ATCO Gas Australia Midwest and Southwest Gas Distribution
System

REVIEW OF TECHNICAL ASPECTS OF ATCO REVISED ACCESS ARRANGEMENT 2025-29

Report prepared for:
ERA
April 2024

Figure 3.2: ATCO's annual planning process

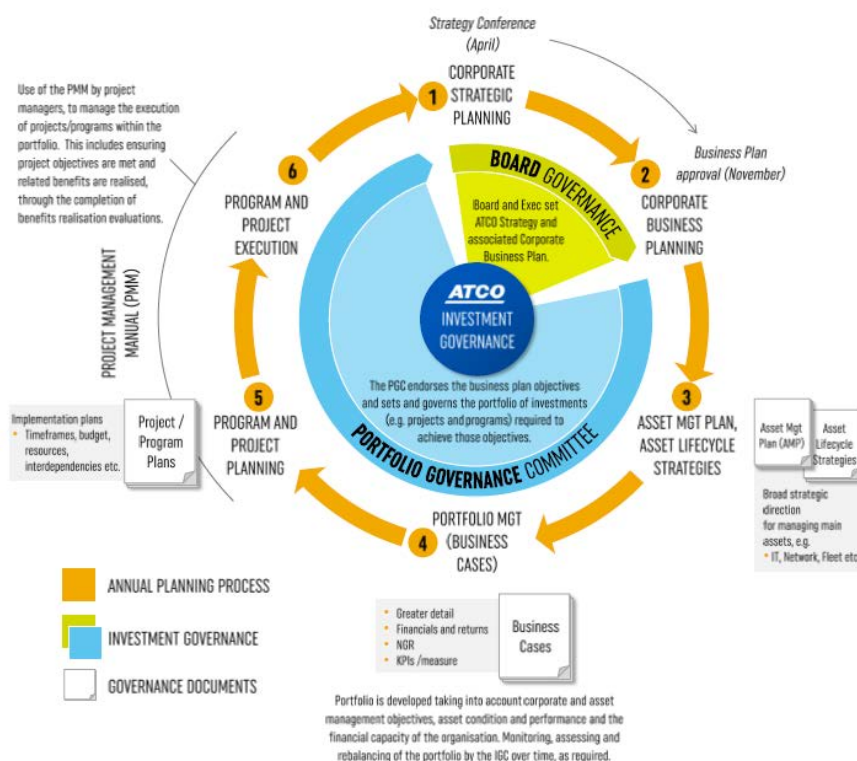
118. In Step 4 of Figure 3.2, ATCO manages ‘portfolio construction’, portfolio prioritisation, and applies portfolio ‘governance’, where the portfolio is comprised of the programs and projects identified in the Business Plan.¹¹

121. However, we comment on what we consider to be a shortcoming in ATCO’s portfolio construction, and prioritisation process in section 4.3.2, as it has been applied to development and review of the capex forecast.

Figure 3.3: ATCO's asset management document framework

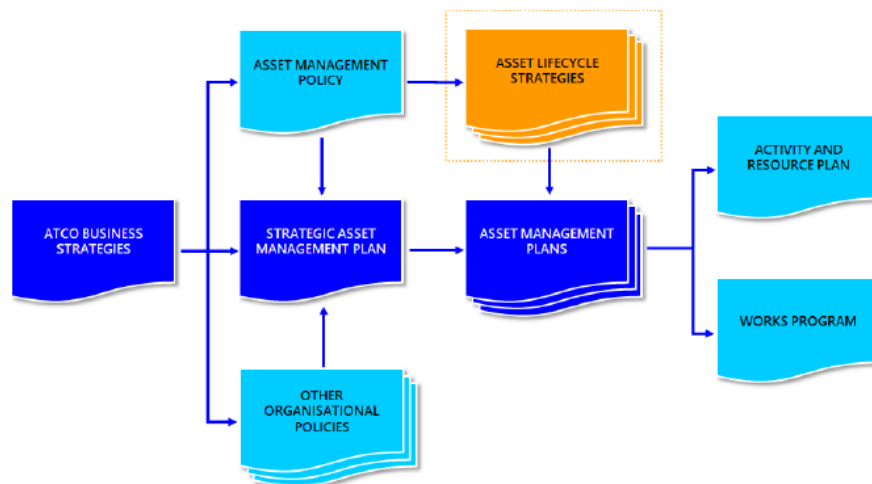
114. ATCO's asset management framework focuses on gas network and STEQ assets (which we discuss in ATCO's IT management approach in section 6.6.2). We note that ATCO's asset management framework and the documents within it are materially unchanged since its AA5 submission. We consider that the framework is consistent with good industry practice.
115. ATCO's Strategic Asset Management Plan (SAMP) outlines the long-term strategy for the GDS and alignment to the corporate strategies. It describes ATCO's Asset Management System and Asset Management Plans and Strategies. It is the cornerstone of ATCO's asset management approach. The SAMP does not explicitly deal with network stranding risk as a result of the energy transition described in section 2. Whilst separate ATCO

116. The Asset Lifecycle Strategy (ALS) documents have many of the typical features of good quality documents of this sort, providing insights into the more detailed work activity and expenditure and the drivers of the expenditure. However, the ALS documents do not clearly provide the following:

- Clear identification of the planned versus actual historical activity and expenditure for each asset class;
 - Discussion of the variance and the reasons for variance between planned and delivered work and expenditure; and

117. Further to deficiencies resulting from the absence of links to stranded asset risk, the absence of the clear links to historical plans, expenditure (including variances) and performance outcomes, frustrates attempts to understand fully the basis for the planned work and is not reflective of good industry practice.

Figure 7.4: ATCO AA5 actual and AA5/AA6 forecast Ancillary Services opex (\$m, real Dec 2023)

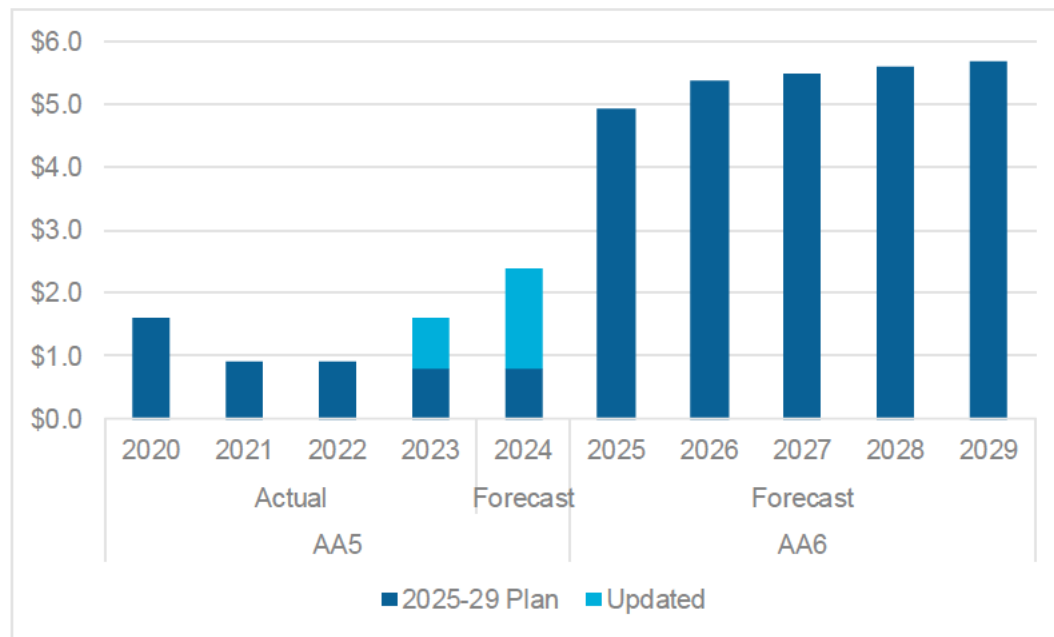
796. ATCO proposes a significant step increase in its cost of Ancillary Services as shown in Figure 7.4.

797. We have included updates to the costs incurred in 2023 and expected to be incurred in 2024, totalling \$1.6 million and \$2.5 million respectively in Figure 7.4.²⁶⁴
